PROPOSED TECHNICAL SPECIFICATION CHANGE

SURRY POWER STATION

DISCUSSION OF  
PROPOSED TECHNICAL SPECIFICATION CHANGE  
SURRY POWER STATION

Offsite Organization for Facility Management and Technical Support

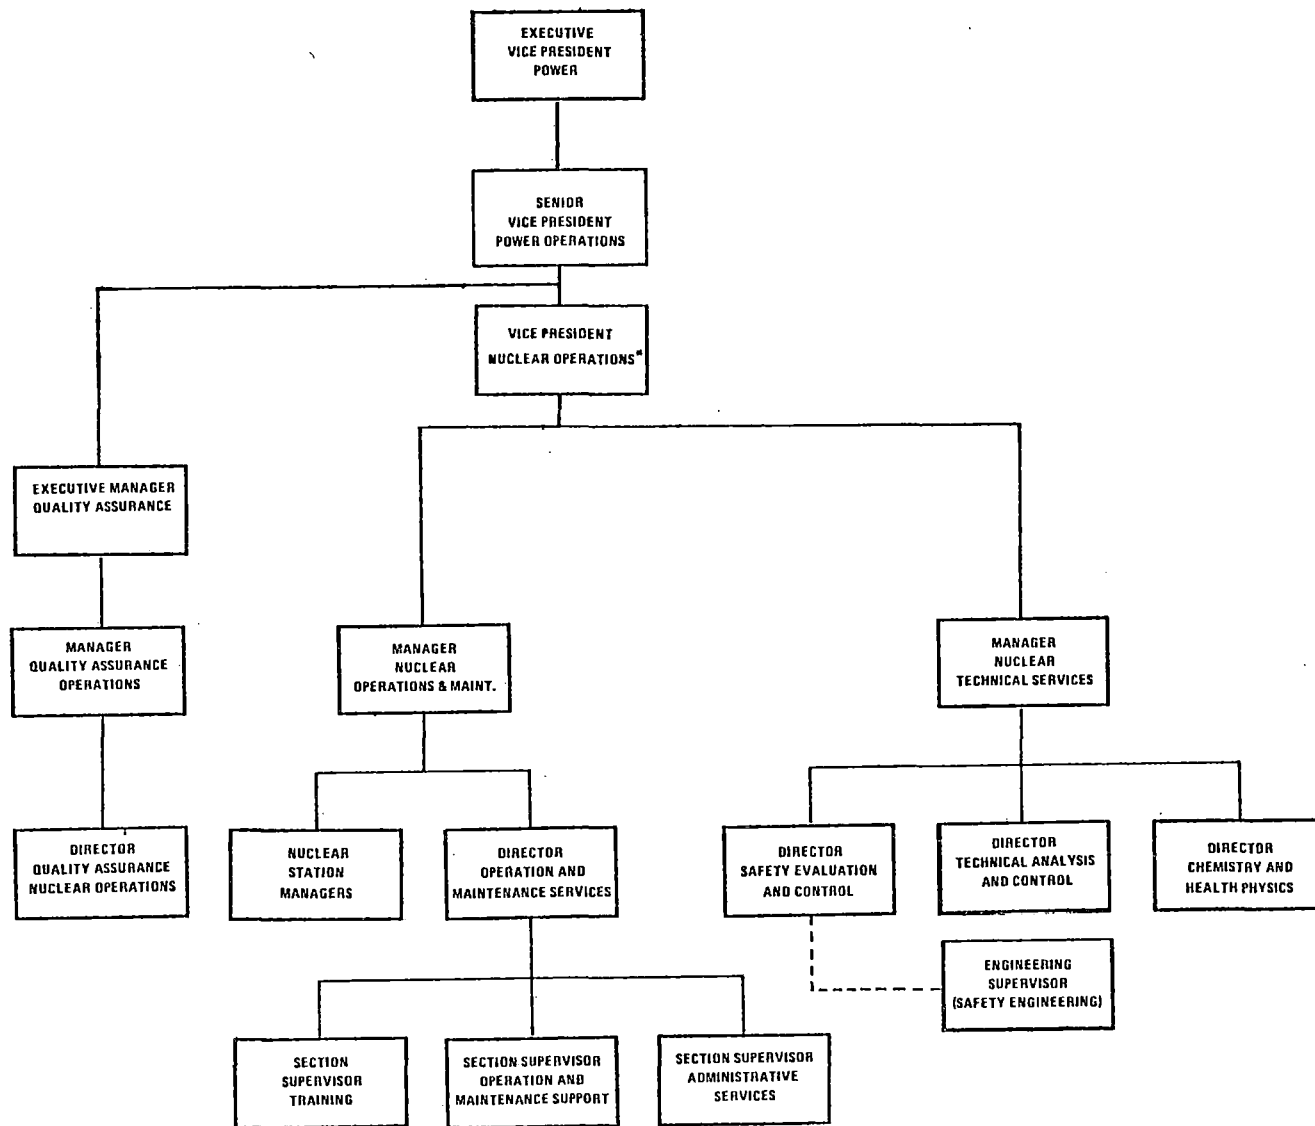
Technical Specifications Figure 6.1-1 has been revised to show the new structure of the offsite organization for facility management and technical support. Information provided by Figure 6.1-1 was previously provided by Figures 6.1-1 and 6.1-2. The previous positions of Senior Vice President-Power and Vice President-Power Supply and Production Operations have been deleted from the Technical Specifications. The deleted positions have been replaced by the Executive Vice President-Power, the Senior Vice President-Power Operations, and the Vice President-Nuclear Operations. All previous references to the Senior Vice President-Power and Vice President-Power Supply and Production Operations positions have been revised to reference either the Senior Vice President-Power Operations or the Vice President-Nuclear Operations positions.

As indicated by Figure 6.1-1, the Manager-Nuclear Operations and Maintenance and the Manager-Nuclear Technical Services replace the previous position of Director-Nuclear Operations. Both managers will report to the Vice President-Nuclear Operations. The Manager-Nuclear Operations and Maintenance has responsibility for the supervision of the Nuclear Station Managers in the operation and maintenance of the Company's operational nuclear units. Both Nuclear Station Managers and the Director-Operation and Maintenance Services report to the Manager-Nuclear Operations and Maintenance. The Director-Operation and Maintenance Services is responsible for coordinating operational and maintenance support with nuclear unit activities. The Section Supervisor-Training, the Section Supervisor-Operation and Maintenance Support, and the Section Supervisor - Administrative Services will report to the Director-Operation and Maintenance Services.

# SURRY POWER STATION ORGANIZATION CHART

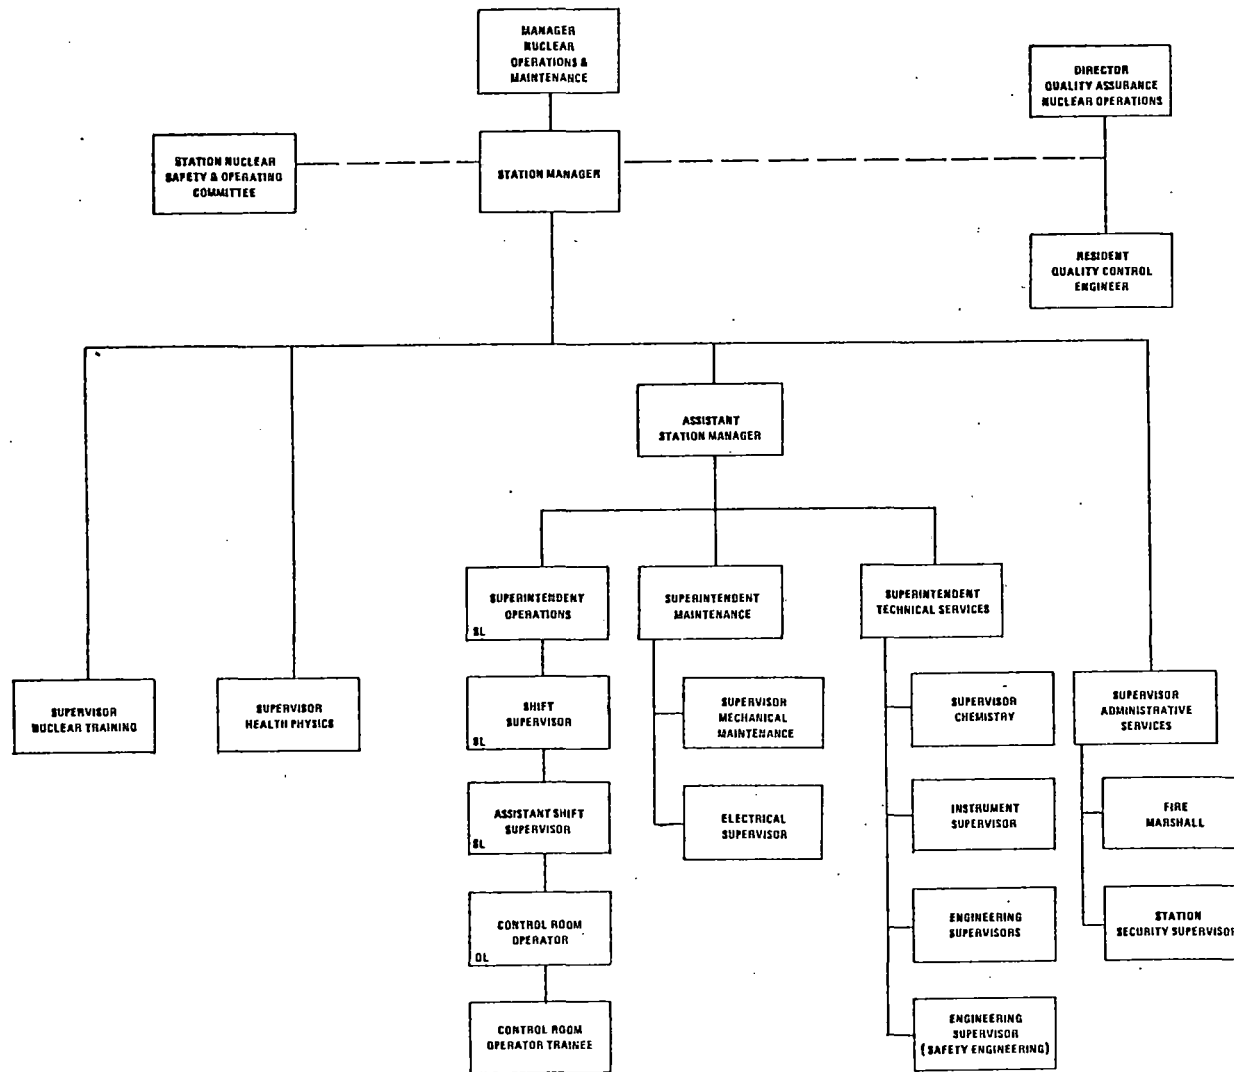
Technical Specification Figure 6.1-2 has been revised to show the new structure of the Surry Power Station organization. Figure 6.1-3, which previously provided this information, has been deleted. As explained above, the Station Manager reports to the Manager-Nuclear Operations and Maintenance. Our August 4, 1980 submittal (Serial No. 671) proposes revising Section 6.0 to add the new position of Assistant Station Manager to the Surry Power Station organization. The Assistant Station Manager will be directly responsible for the safe operation and maintenance of the power station. He will serve in a coordinating capacity to the Station Manager for the off-site activities of the Station. During the absence of the Station Manager, the Assistant Manager will act as the Station Manager. The Assistant Station Manager will also be the Vice Chairman of the Station Nuclear Safety and Operating Committee (SNSOC). The Superintendent-Operations, the Superintendent-Maintenance, and the Superintendent-Technical Services will report to the Assistant Station Manager. All three of these superintendents will remain members of the SNSOC.

The positions of Operating Supervisor and Auxiliary Operator have been eliminated from the organization chart. In addition, the position title of Assistant Control Room Operator has been revised to Control Room Operator Trainee. The positions of Maintenance Coordinator and Mechanical Supervisor have been replaced on the station organization chart by the position of Supervisor-Mechanical Maintenance. Both the Maintenance Coordinator and the Mechanical Supervisor report to the Supervisor-Mechanical Maintenance. Other title changes made to the organization chart include the change of Supervisor-Safety Engineering to Engineering Supervisor (Safety Engineering), the change of Engineering Supervisor to Engineering Supervisors to reflect the two positions of Engineering Supervisor-Performance and Tests and Engineering Supervisor-Design Changes and Projects and, the change of Training Supervisor to Supervisor-Nuclear Training. The Supervisor-Health Physics position has been shifted such that he will now report directly to the Station Manager instead of reporting to the Superintendent-Technical Services. The positions of Supervisor-Nuclear Training and Supervisor-Administrative Services will also report to the Station Manager.
